**TOWN OF HERNDON, VIRGINIA  
ARCHITECTURAL REVIEW BOARD  
WORK SESSION AGENDA  
SEPTEMBER 4, 2019  
HERNDON COUNCIL CHAMBERS BUILDING  
765 LYNN STREET  
7:30 P.M.**

**Case Number & Type:** ARB #19-33; New Construction  
**Case Summary:** Install new drive-thru clearance bar and order canopy on the commercial property for redesign of a fast food restaurant.  
**Case Location:** 1071 Elden Street, McDonald's

# NextGen 24" Individual Letter Set

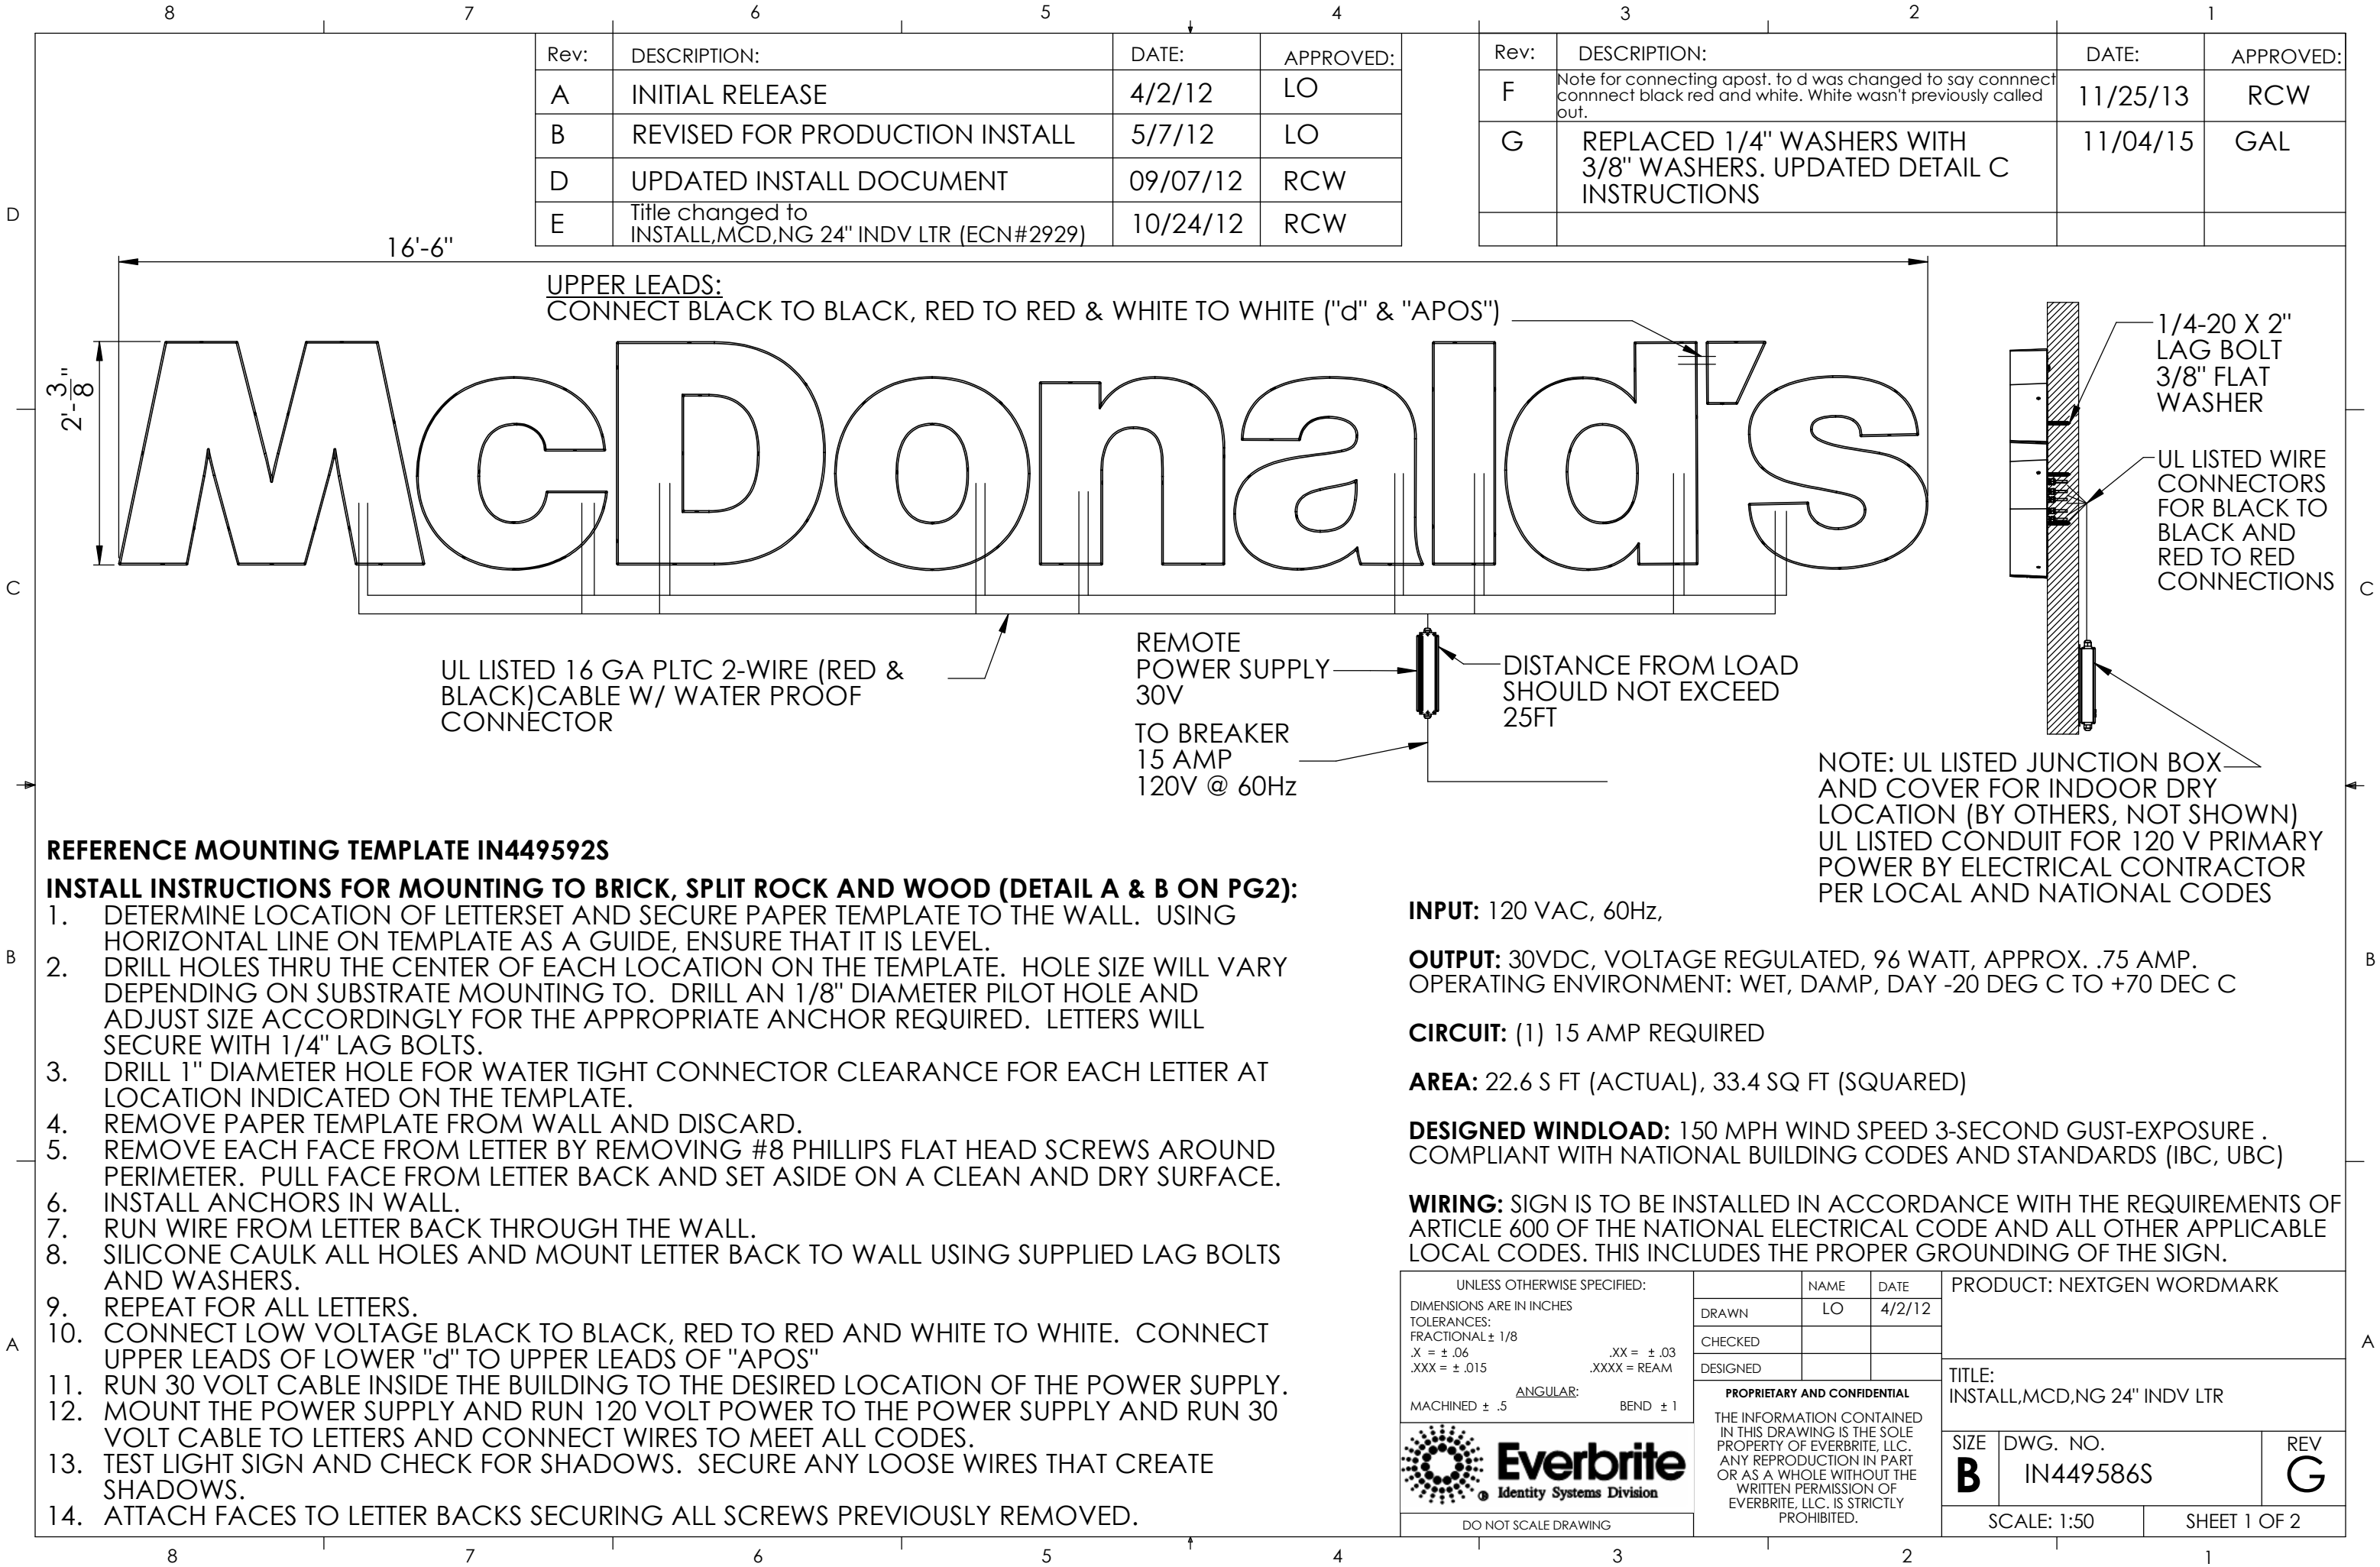
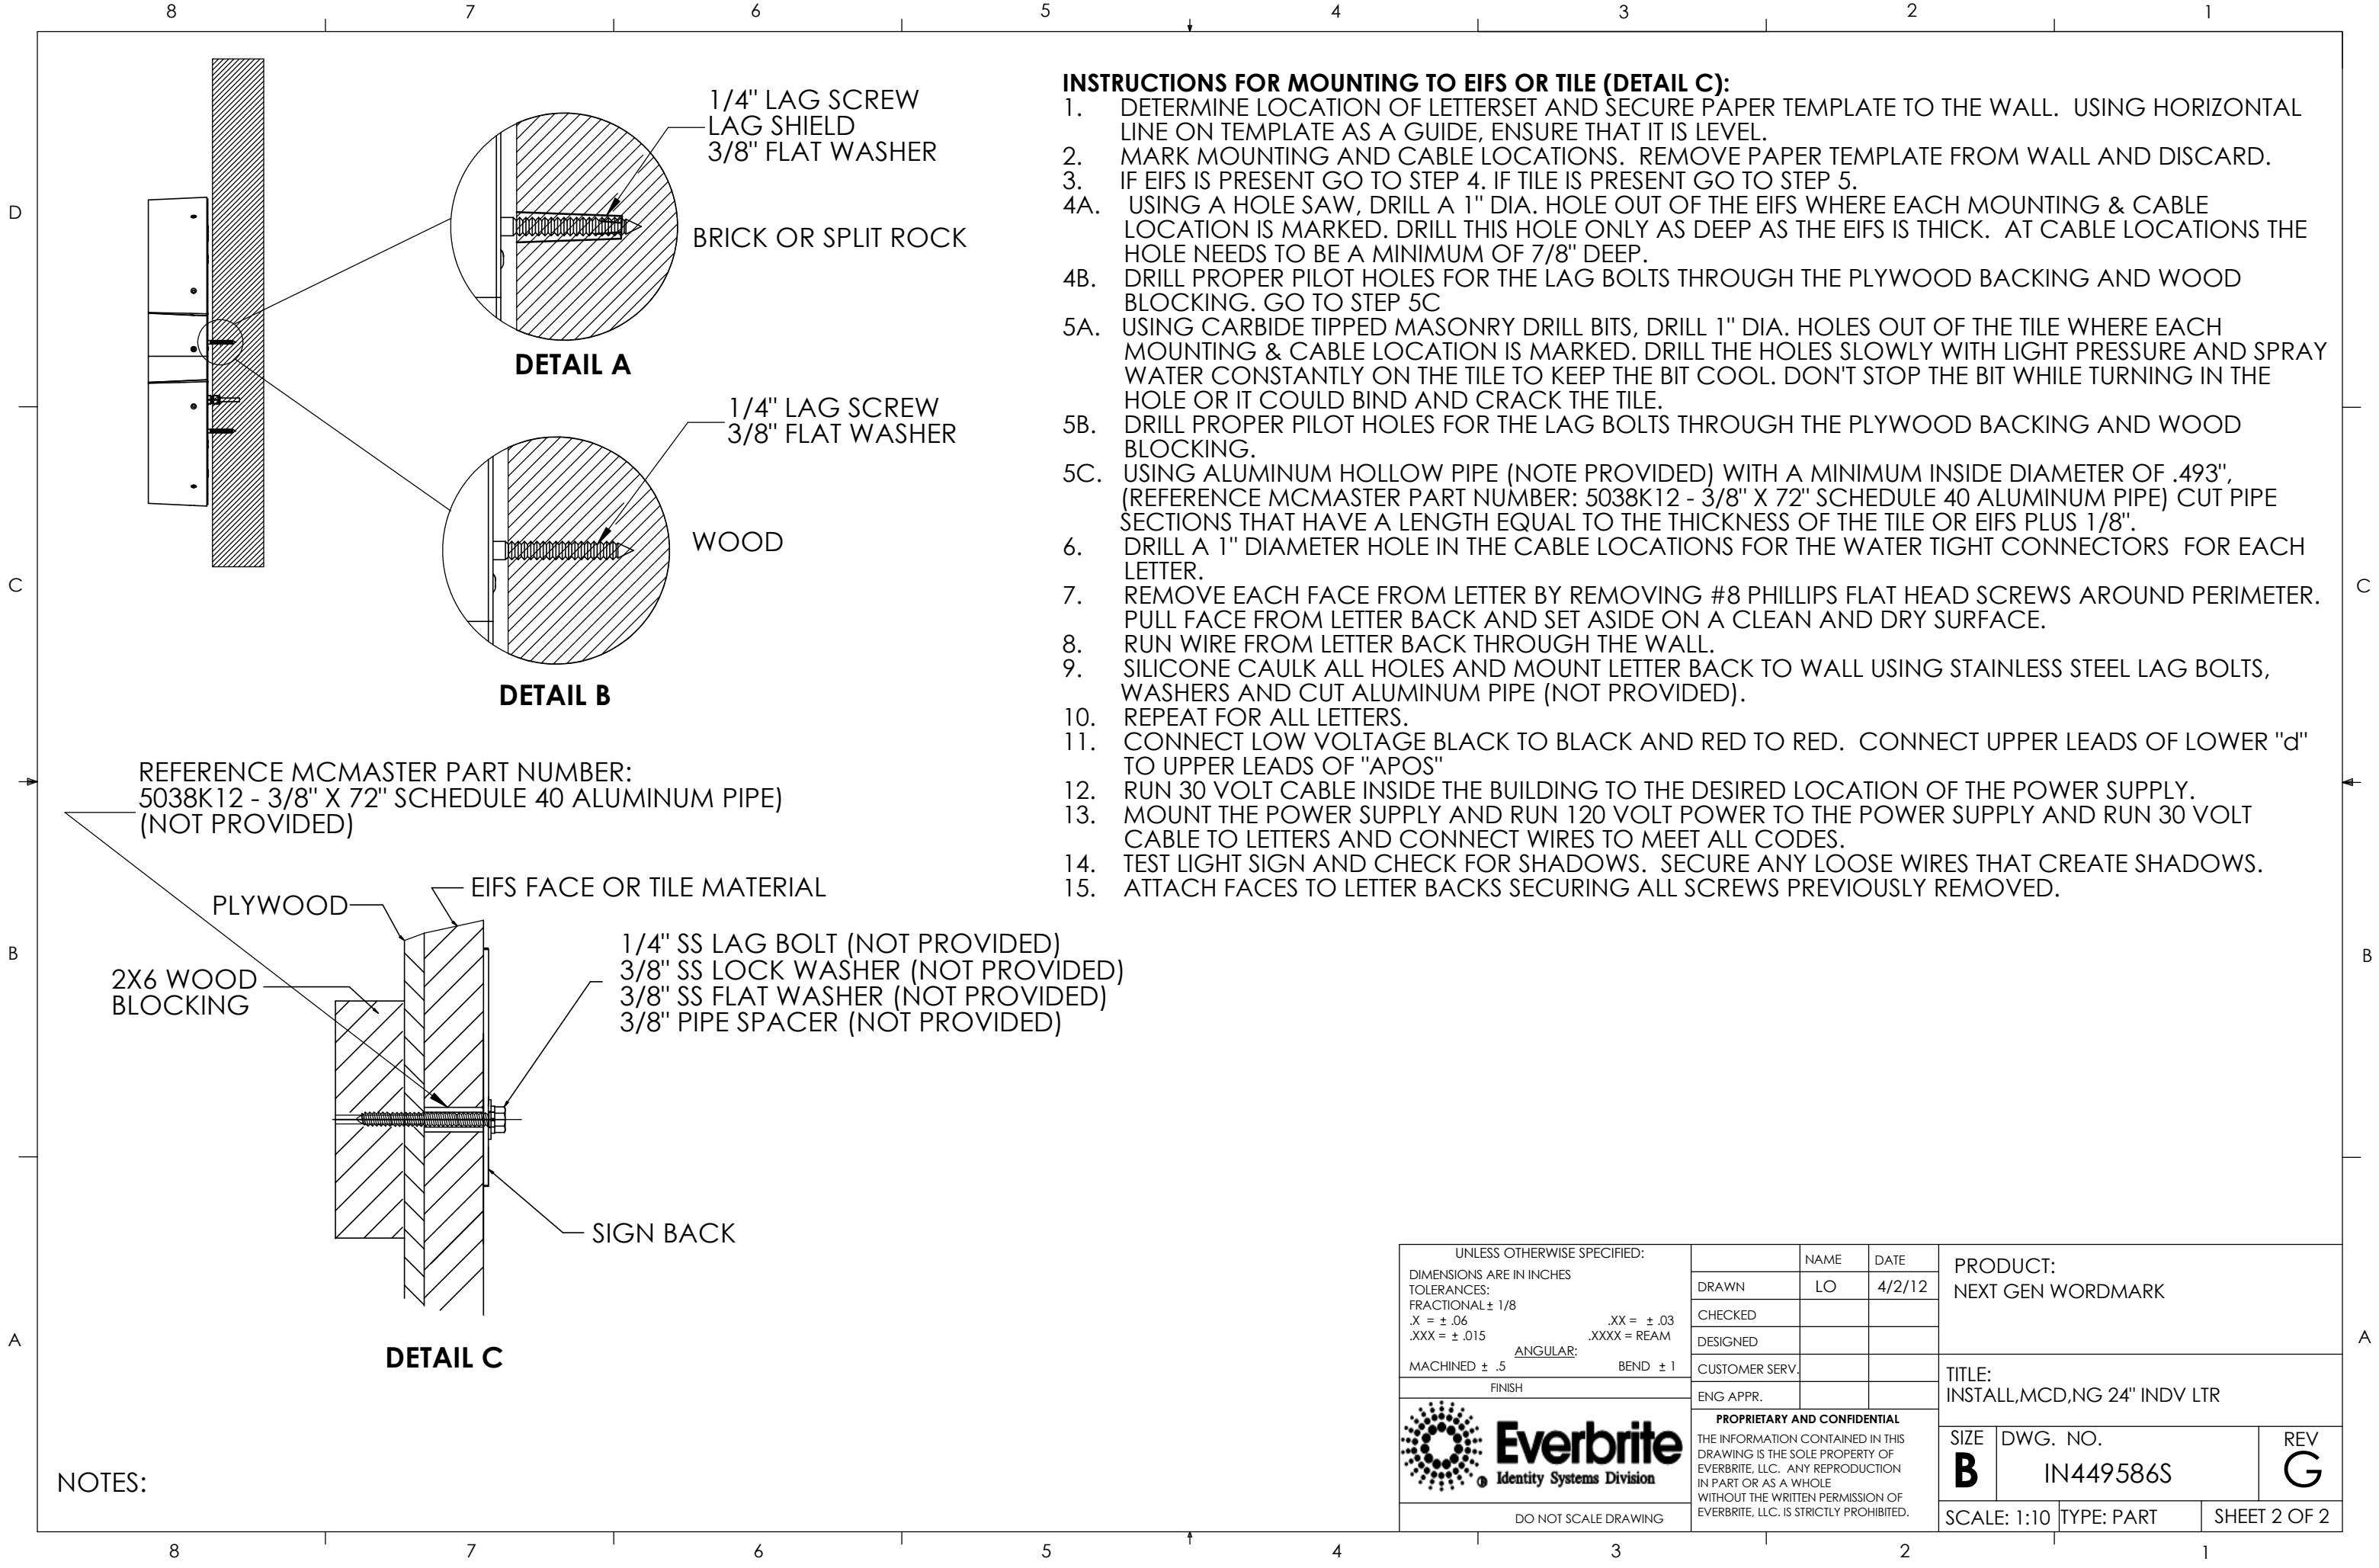
Staff has noted that the two awning signs are not a sign type that is authorized under Section 141.4, Tables 141.4(a) and (b). Thus, the canopy signs are not permitted by Zoning Ordinance and the Board may not act on this case until the application complies with Town's Zoning Ordinance. The applicant may submit revised elevation drawings and details that change the orientation and attachment of the awnings signs to adhere to the wall sign and/or projecting sign definitions and standards, which are permitted in the CS zoning district or remove the awning signs altogether. If the "Welcome" signs attached directly to the wall, they can be permitted as a wall sign. Alternatively, they can be attached beneath the canopy and perpendicular to the wall as a projecting sign, which is also a permitted sign type. If the applicant is amenable to any of these options and can submit revised drawings no later than September 11, 2019, staff may be able provide the Board updated recommendations for the Board's consideration and action, assuming zoning compliance is achieved.

| <b>Recommended Motion:</b>  | Motion for continuance of ARB #19-34, in accordance with Alternative #4, to allow staff and the applicant to: <ol style="list-style-type: none"><li>1. Revise ARB #19-34 to include only the sign types permitted in the CS zoning district.</li></ol>                                                                                                              |
